Attachment 2 – Applicant's response to raised items dated 17 November 2018

Re: SP 63212, Nos 6 -12 Dumaresq Street, Campbelltown - Development Application 4204/2016/DA-RA - Demolition of existing structures and construction of mixed use development comprising 85 residential units, four levels of basement car parking, one level of retail, two levels of commercial space

Figure 24: Typical features of a 'Type B' hoarding (elevation).

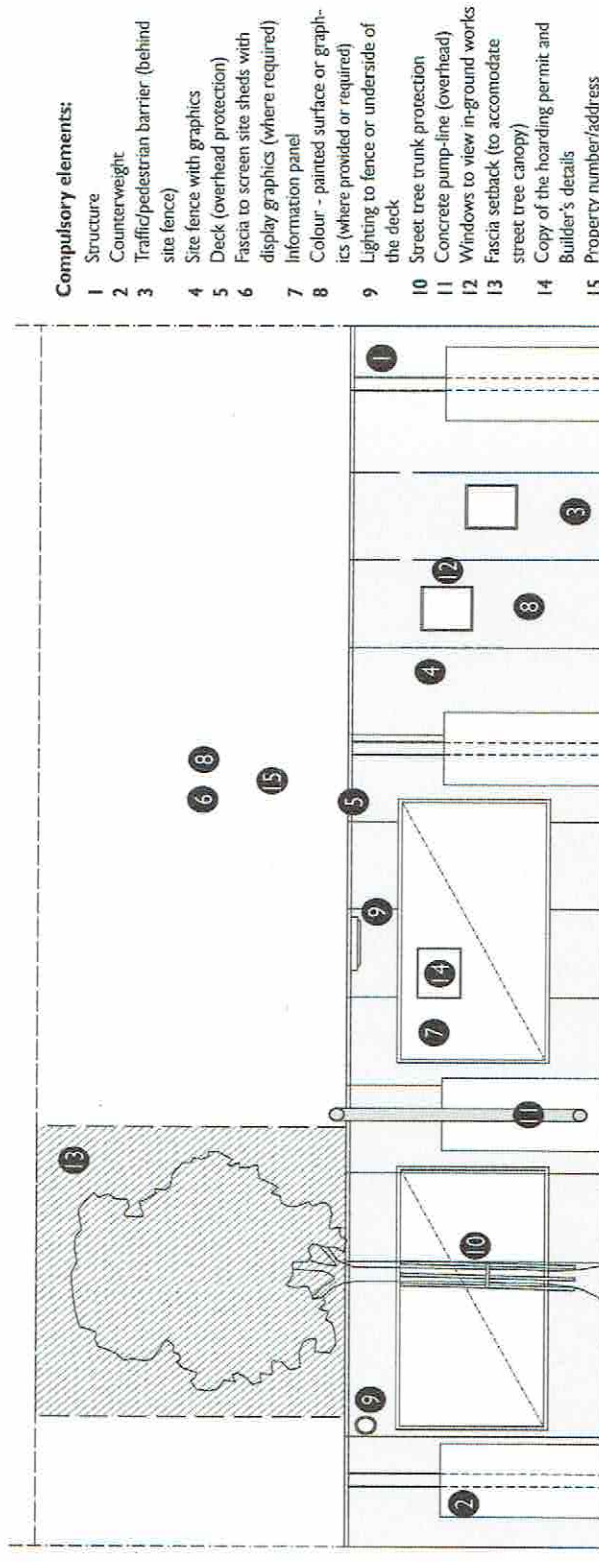
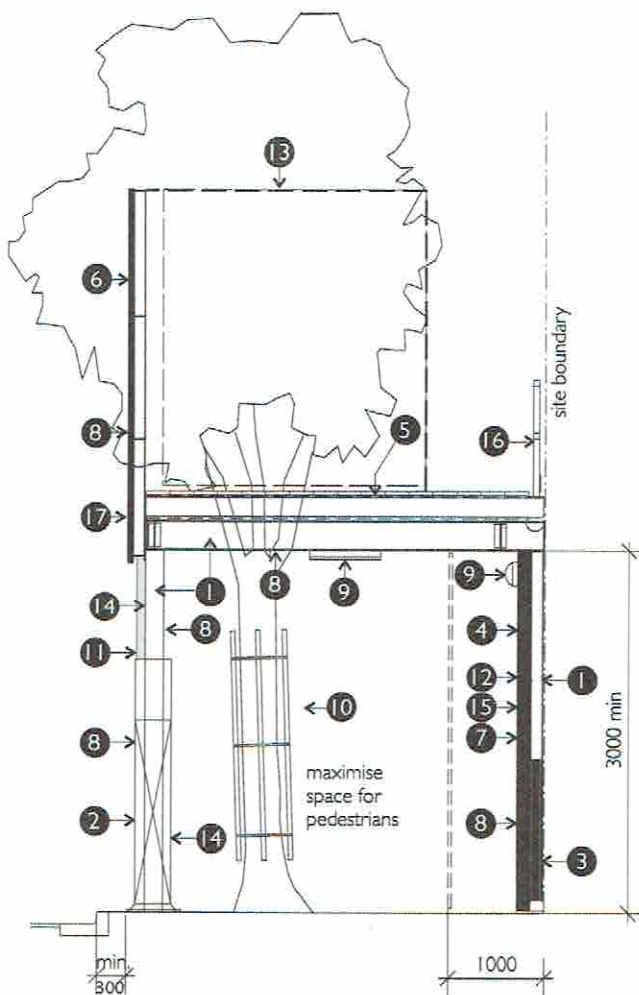
This aspect was discussed at the meeting and we assume that this relates to the concerns expressed by the cinema operators for safe pedestrian access between the buildings during the demolition and construction phases, given the location of the egress point from the cinemas.

It is proposed to build a B Class Hoarding between the Cinema and the new development providing protection and access.

It is proposed to erect a B Class Hoarding in accordance with the Australian Standards (refer to **Annexure C**) and the consent could be conditioned accordingly.

The hoarding will be to the Work-safe requirements for the construction of B Class Hoardings.

The structure will be lined with Plywood, painted, and well-lit so as to provide a safe access.

Way signage will be provided and council can suggest decorative photographic.
